**Business Unit Mercedes-Benz Trucks**  
**Bodybuilder Information**  
 Issue 05/2026

<b>Date:</b>	20.03.2026	<b>E-Mail:</b>	
<b>Author, Dept.:</b>	Bodybuilder Management	<b>Applicability:</b>	International
<b>Vehicle class:</b>	Actros / Arocs / Atego / eActros		
<b>Please note:</b>	This information bulletin and its contents are intended for international use and are not adapted to a specific country. Consequently, vehicle features and equipment items may differ in individual markets, e.g. due to registration requirements. Please address any queries to the contact person for your market. We accept no liability for the accuracy or completeness of the information provided.

## Changes to the License Plate Flap

Extension of the license plate flap:

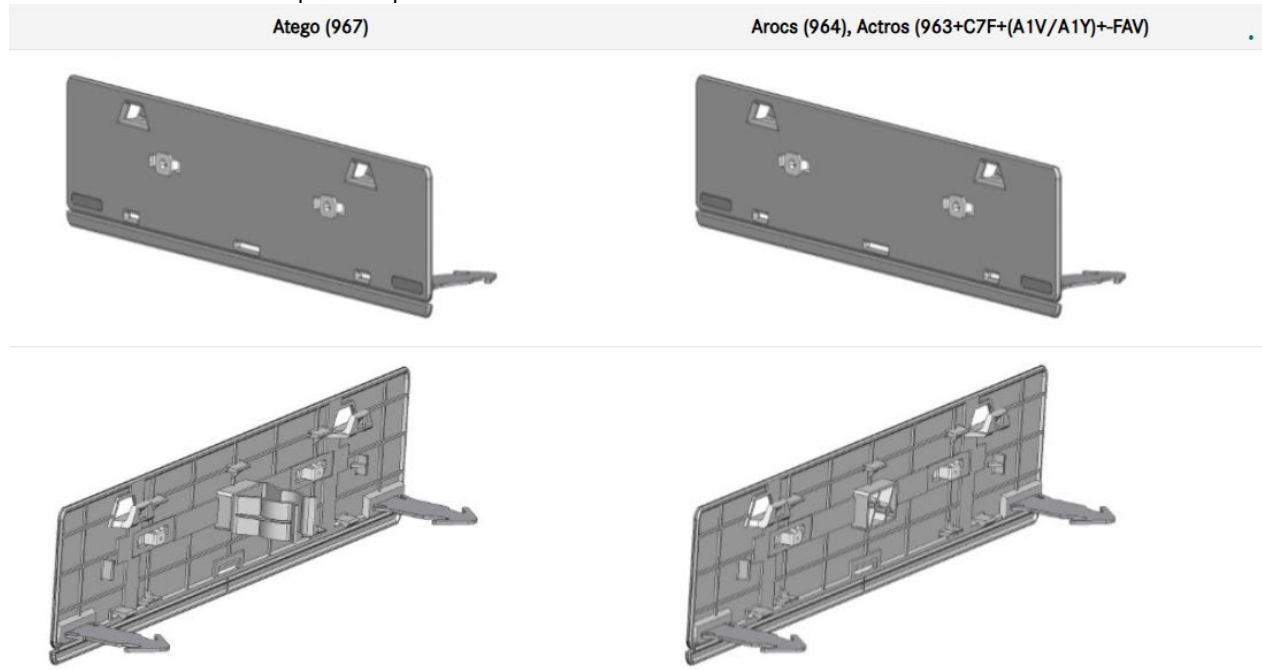
- a) Vehicles equipped with the ProCabin (FAV) already comply with the EU regulation.
- b) For vehicles of the model series Atego (967), Arocs (964) and Actros (963 + C7F + A1V/A1Y + - FAV), the license plate flap will be extended with the production release date (DD quota) of 01 June 2026 and certified according to EU Regulation (EC) 2021/535/III.

- c) For the remaining vehicles of model series 963 and eActros (983), no technical measures are required. The license plate flaps will be certified according to the new EU Regulation 2021/535/ III starting on 01 April 2026.

For the vehicles listed under section b) that are ETG-compliant, with a production date before 01 June 2026 and a registration date on or after 07 July 2026, the following applies:  
 Exceptions will be required and must be obtained through the respective local homologation representative from the local authorities.

For the vehicles listed under section b) that are non-ETG-compliant, with a production date before 01 June 2026 and a registration date on or after 07 July 2026, the following applies:  
 Whether exceptions are required must be reviewed by the local homologation representative.

If no exemption can be granted in the respective country, the license plate flap may need to be replaced.

For the vehicles listed under section c), the following applies:  
 For vehicles built before 01 April 2026, the license plate flap is still approved according to Regulation 1003/2010/EC. If these vehicles are registered on or after 07 July 2026, exemption approvals must also be reviewed in accordance with section b).
